Applicant:	NYLAND	Examiner:	K. ROWAN
Serial No.:	10/848,829	Group Art Unit:	3643
Filed:	MAY 19, 2004	Docket No.:	14684.1US01
Title:	ARM SUPPORT FOR USE WITH A FISHING ROD

APPELLANT'S BRIEF ON APPEAL

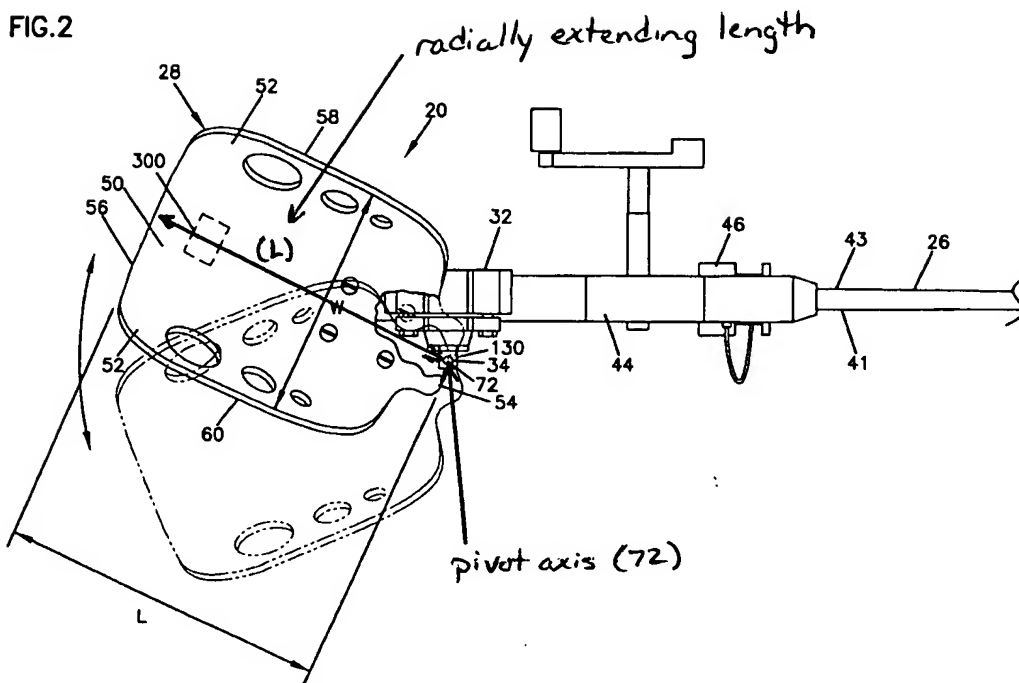
Claim 10 requires the length of the forearm receiving member to extend radially outward from the pivot axis and also specifies that the length of the channel extends between open front and rear ends of the forearm receiving member. Annotated Figure 2 of the present application (shown below) illustrates this feature where the length (L) of the member 28 extends generally radially outward from the pivot axis (72).

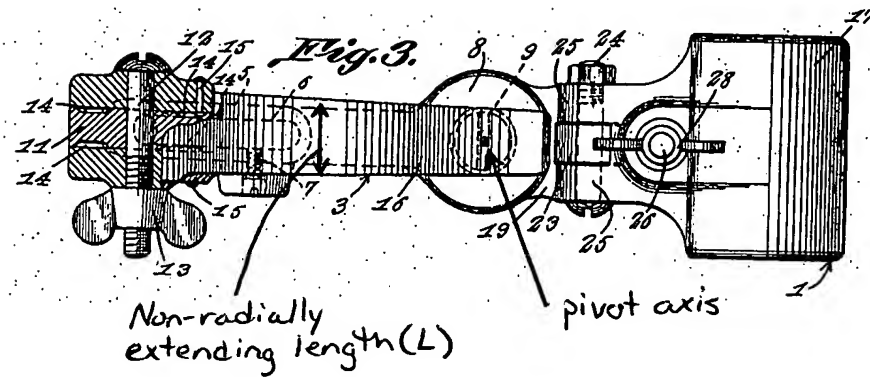
The Examiner has characterized an arm clamp 3 of Roberts as a member defining a channel that extends between open front and rear ends. A bolt 9 of Roberts is characterized as a pivot member. In rejecting claim 10, the Examiner interpreted the length of the "channel" of Roberts as the "distance along the curve of the arm in the plane of the paper." This is not the same length specified in claim 10 because it does not extend between the open front and back ends of the arm clamp 3.

Referring to annotated Figure 3 of Roberts (below), the device is shown with the pivot axis (i.e., the bolt 9 axis) coming out of the page. Applicant's annotated Figure 2 (above) also shows the pivot axis (72) coming out of the page. Applicant's annotated Figure 2 also shows the length L extending between the open ends of the device relative to the pivot axis (72), i.e., the length L extends generally radially outward from the pivot axis (72). Referring to annotated Figure 3 of Roberts (below), the length (L) of the clamp 3, which extends between open front and back ends, does not extend generally radially outwardly from the pivot axis, as required by claim 10.

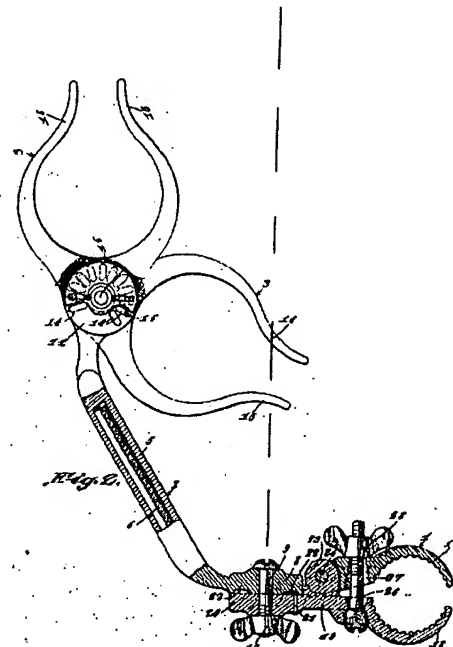
Additionally, claim 13 further provides that the "forearm receiving member inclines relative to the coupler as the arm cradle extends from the front end to the back end." This clearly is not present in the device of Roberts. For example, as shown below in Figure 2 of Roberts, it can be seen that the clamp 3 of Roberts in no way inclines relative to the coupler as it extends from the open front to the open back of the clamp. Rather, the inclination of the clamp 3 extending from the open front to the open back remains unchanged as the clamp 3 pivots. This provides another reason why claim 13 is not anticipated by Roberts.
